To: T10 Technical Committee
 From: Rob Elliott, HP (elliott@hp.com)
 Date: 24 September 2007
 Subject: 07-090r3 SAS-2 Transmit IDENTIFY three times

Figure 31 — Transmit data path in a SAS phy [changed]

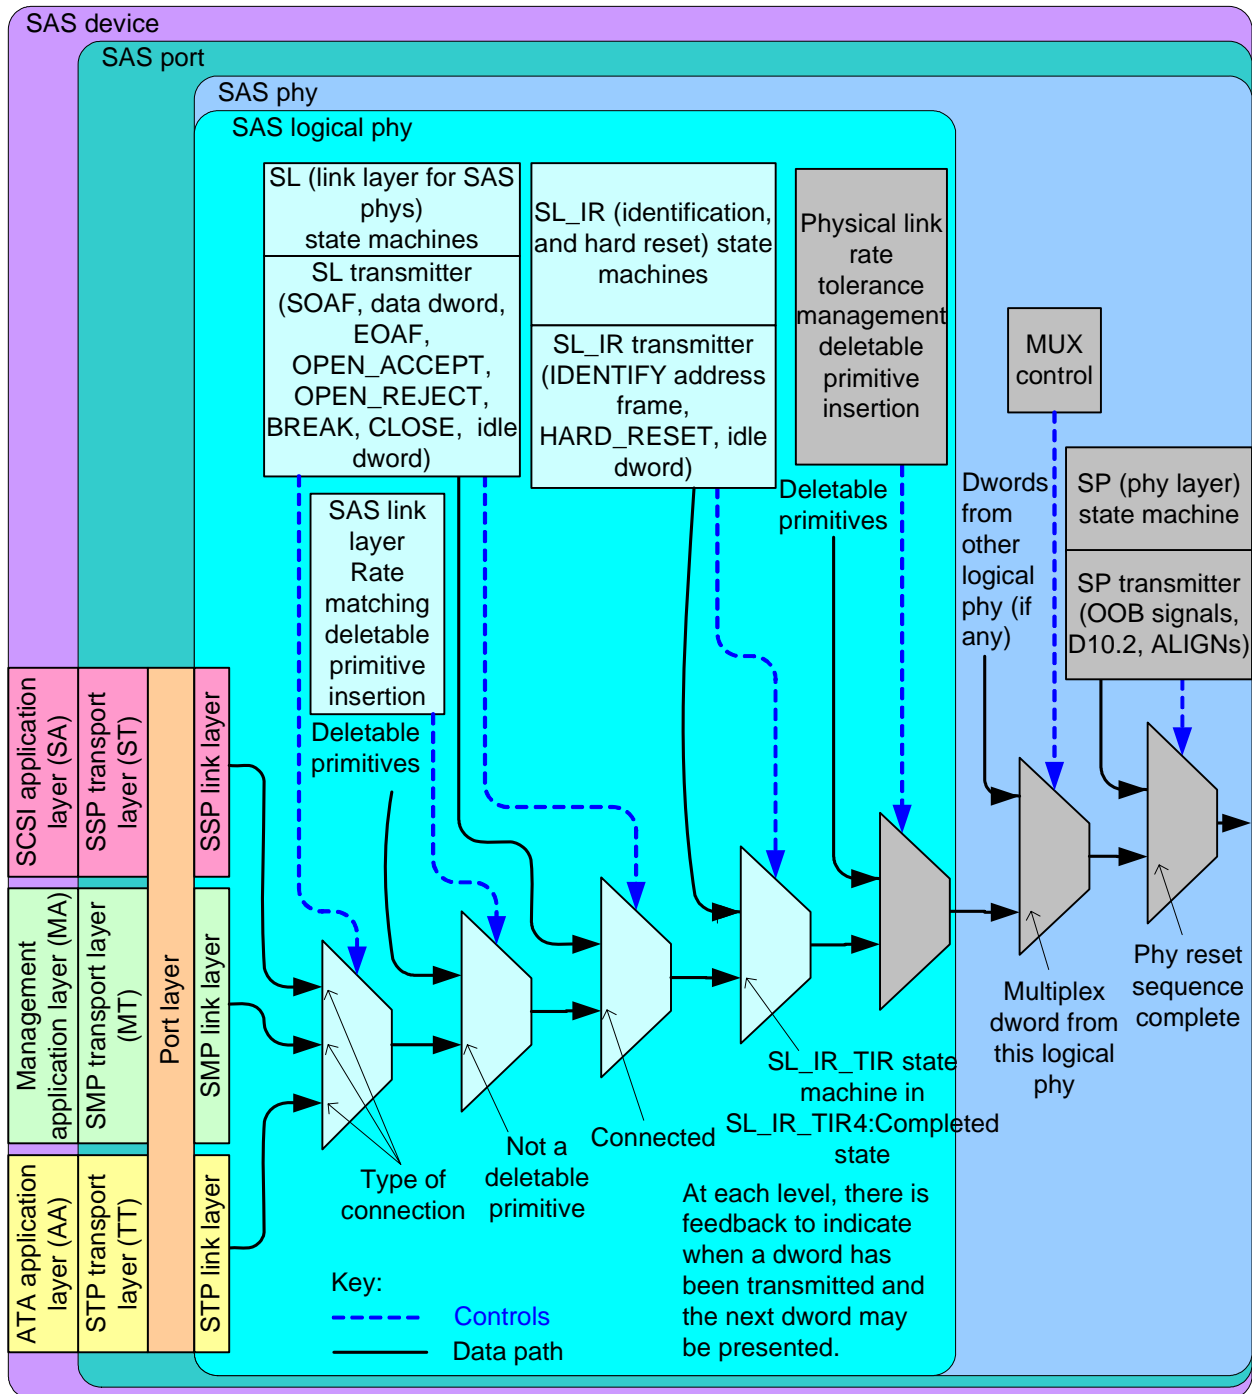
Editor's Note 2: In the figure, changed "Link reset sequence complete" to "SL_IR_TIR state machine in SL_IR_TIR4:Completed state". Changed "Clock skew management" to "Physical link rate tolerance management". Changed "SL_IR state machine" to "SL_IR state machines." Changed "SL state machine" to "SL state machines."

Figure 35 — Transmit data path and state machines in an expander phy [\[changed\]](#)

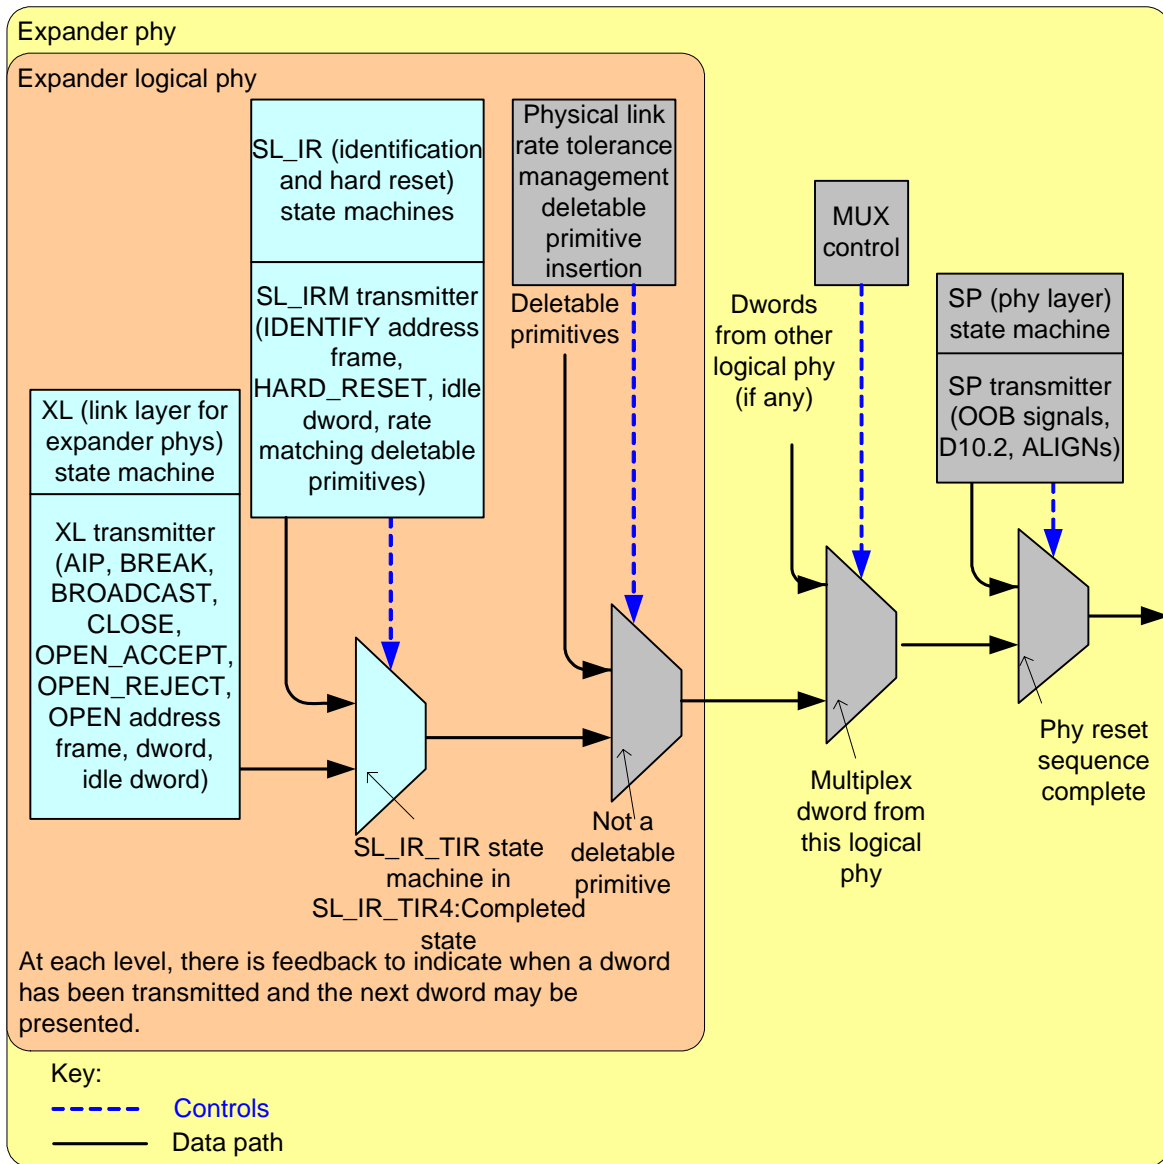
Editor's Note 4: In the figure, changed "Link reset sequence complete" to "SL_IR_TIR state machine in SL_IR_TIR4:Completed state." Changed "Clock skew management" to "Physical link rate tolerance management." Changed "SL_IR state machine" to "SL_IR state machines."

Figure 36 — Receive data path in a SAS phy **[changed]**

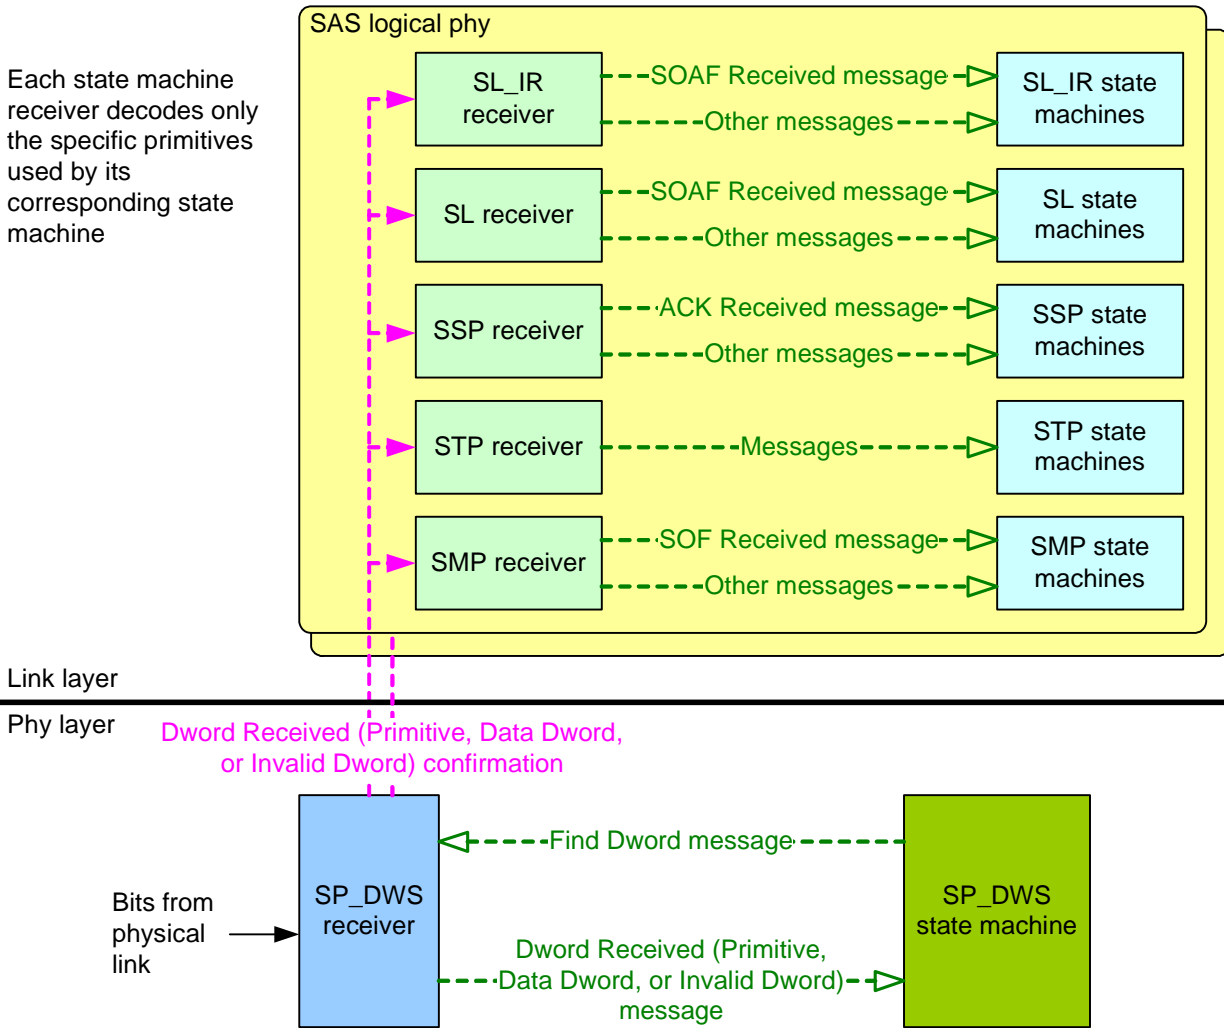
Editor's Note 6: Changed "SL_IR state machine" to "SL_IR state machines"

Figure 37 — Receive data path in an expander phy [\[changed\]](#)

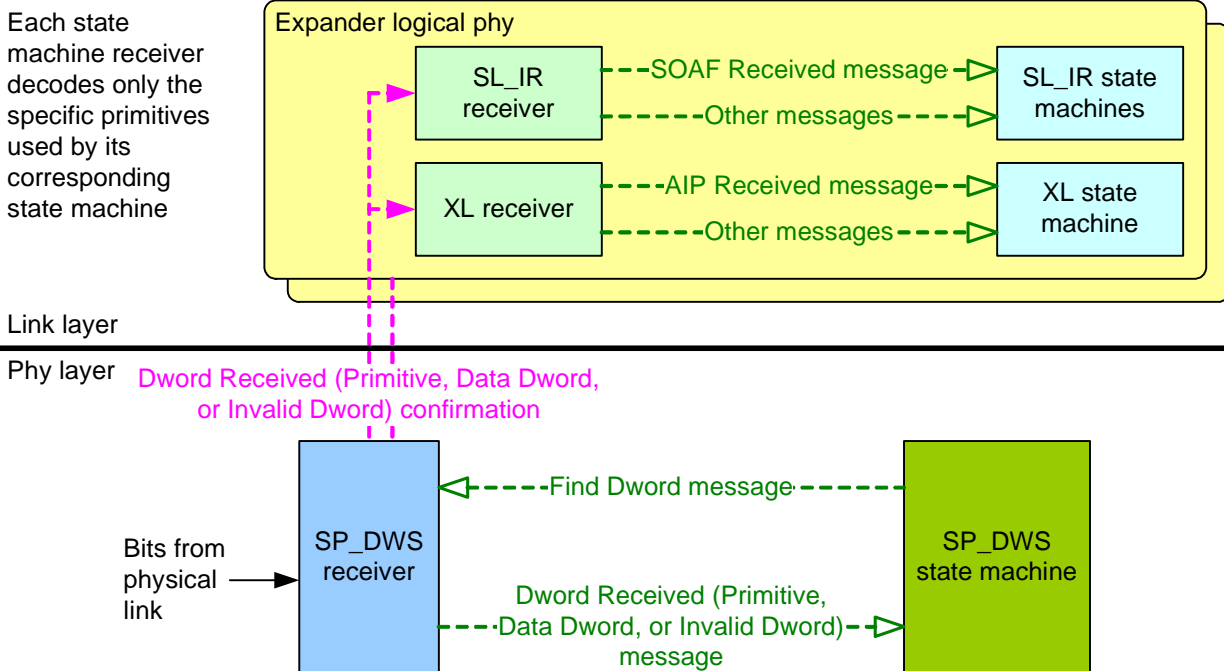
Editor's Note 8: Changed "SL_IR state machine" to "SL_IR state machines"
